Intel[®] 82576EB Gigabit Ethernet Controller Specification Update

Revision 2.85
September 2012

1.10 Introduction

Figure 1. Example With Identifying Marks

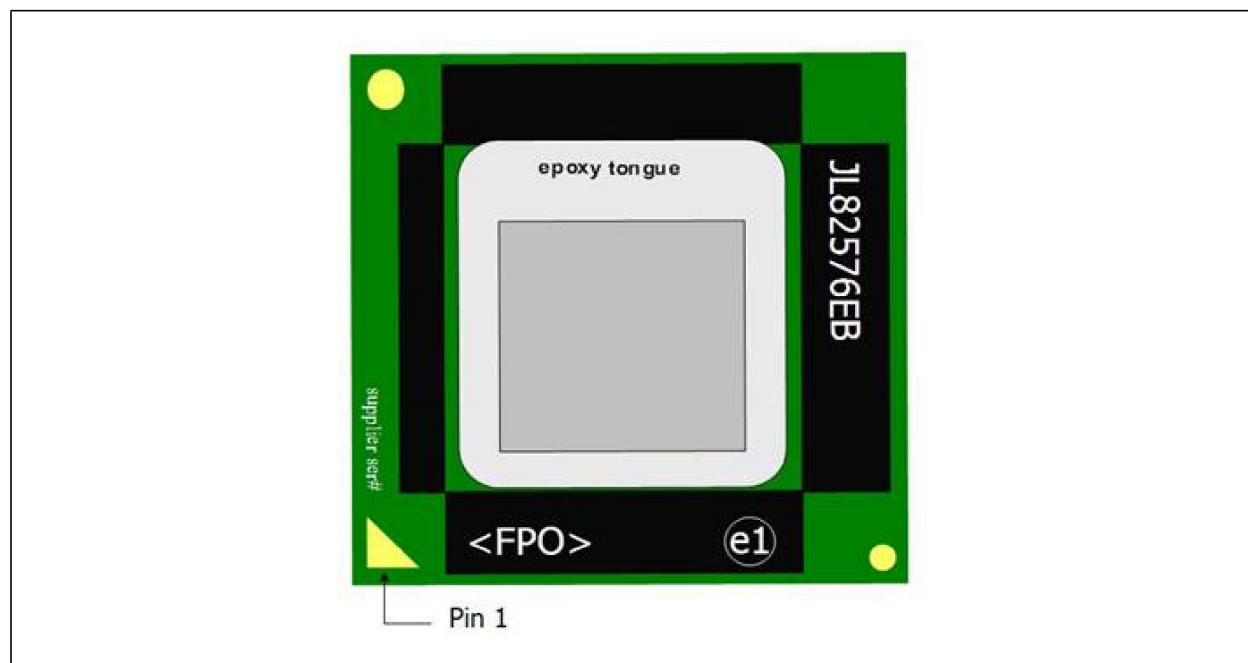
Lead-free parts will have “JL” as the prefix for the product code (vs. “HL”).

The devices can also have a “GB” marking, instead of “EB”. These are functionally equivalent and only used on Intel network interface adapters.

There is an internal designator visible as a dash on the die side of some packages. It’s location may differ. The mark (looks like a dash, approximately 300X1000 µm in size) does not impact function.
